Subject: Response to U.S. EPR Design Certification Application RAI No. 505
(5902,5735,5869,5754,5803,5950,5744), FSAR Ch. 7, Supplement 13
Sent Date: 4/3/2012 3:27:25 PM
Received Date: 4/3/2012 3:26:13 PM
From: WILLIFORD Dennis (AREVA)

QUESTIONS for Instrumentation, Controls and Electrical Engineering 1

Question 07.08-47:

Figure 7.8-47-1—DAS Testing

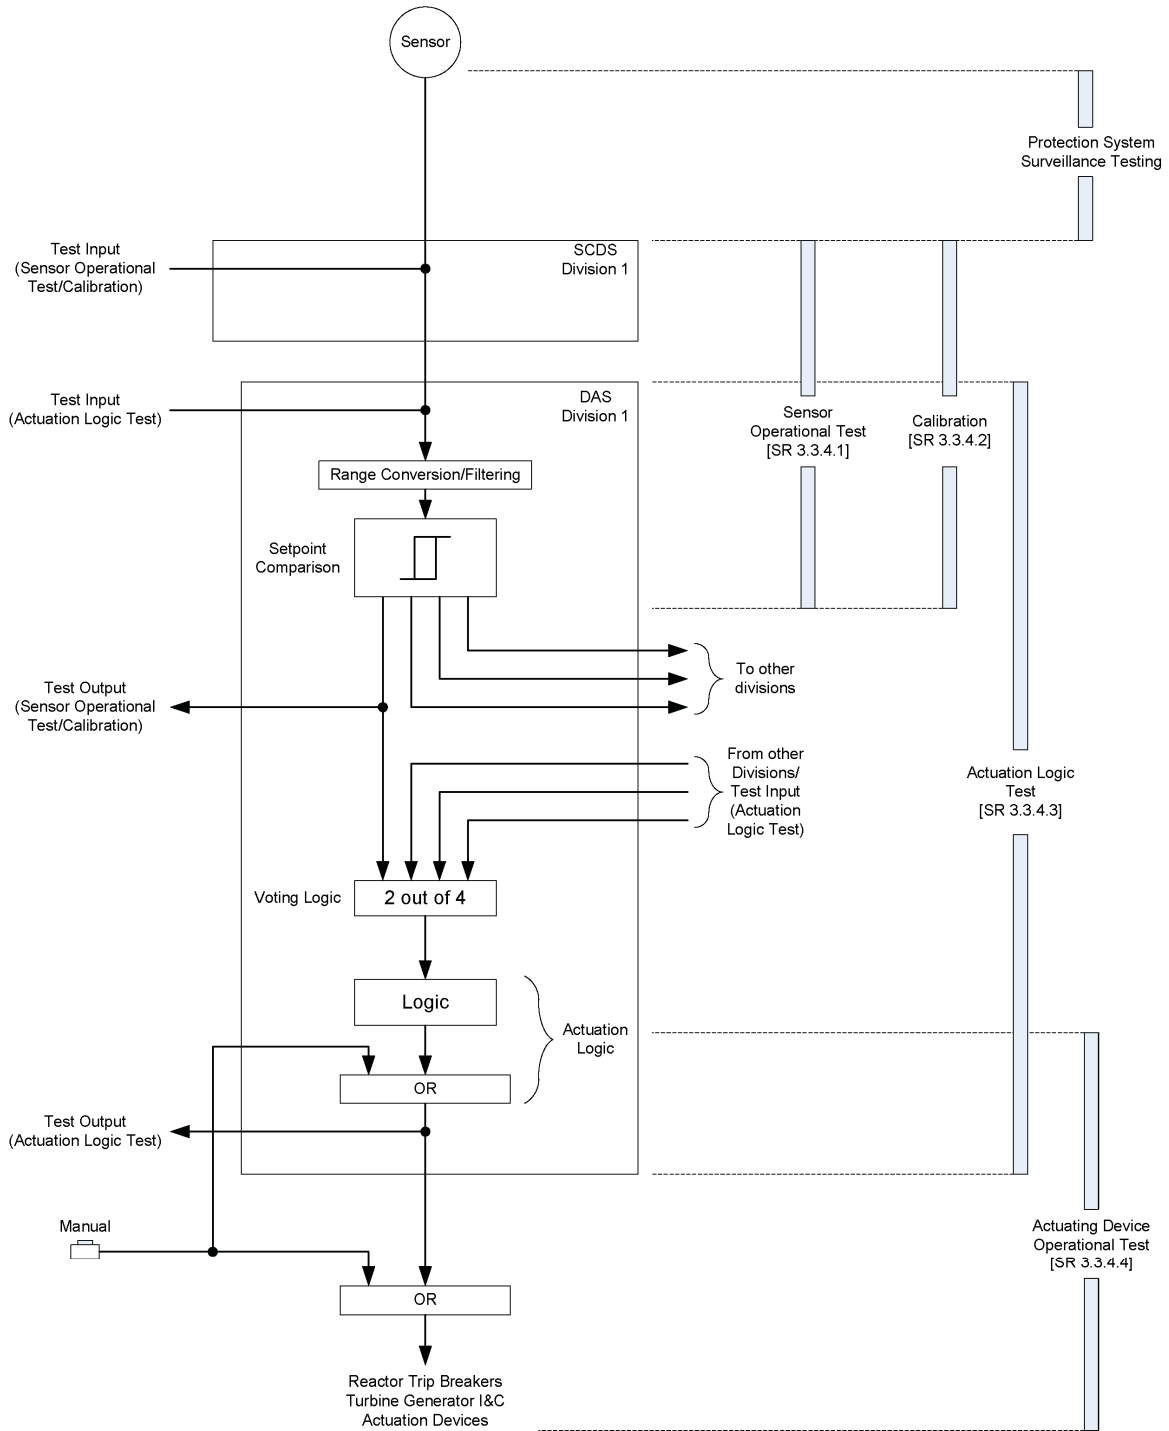
The staff requests the applicant to provide design descriptions demonstrating the diverse actuation system's (DAS's) ability to be tested at power.

The diverse actuation system (DAS) is periodically tested to verify that the system will execute its functions. Technical specifications require that these tests are performed every 24 months. Most of the functions are capable of being tested with the plant at power. The testing of some functions at power would upset plant operation or damage equipment. For these functions, the tests can be performed when the reactor is in shutdown mode. The DAS testing philosophy combines a series of overlapping tests that confirm the system performs as required:

Figure 7.8-47-1 represents the U.S. EPR DAS overlapping test philosophy, and shows which portions of the DAS are periodically tested to meet the surveillance requirements. This figure also shows the general concept for each test. Sensors shared by the protection system (PS) and DAS are tested as part of the PS. These sensors are not tested separately as part of the DAS periodic testing.

A sensor operational test is the injection of a simulated signal into the sensor conditioning and distribution system (SCDS), and capture of the injected signal after it goes through the setpoint comparison logic of the DAS. This process allows verification of operability of the channel, as well as the accuracy and response time. This test is capable of being executed with the plant at power.

Calibration refers to the adjustment, as necessary, of a sensor path so that it responds accurately over a required range to known values of a parameter that the sensor monitors. Calibration includes the devices in the instrument channel, with the exception of sensors, that are required to function for an accurate parameter value to be received by the DAS actuation logic. This test is capable of being executed with the plant at power.

The actuation logic test is the injection of simulated signals into the DAS, and the capture of the injected signals at the output of the DAS. Any possible logic combination can be tested for each function. This test is capable of being executed with the plant at power.

system-level actuation order. Functional testing of these manual controls at power would upset plant operation or damage equipment, so these tests are performed when the reactor is in shutdown mode.
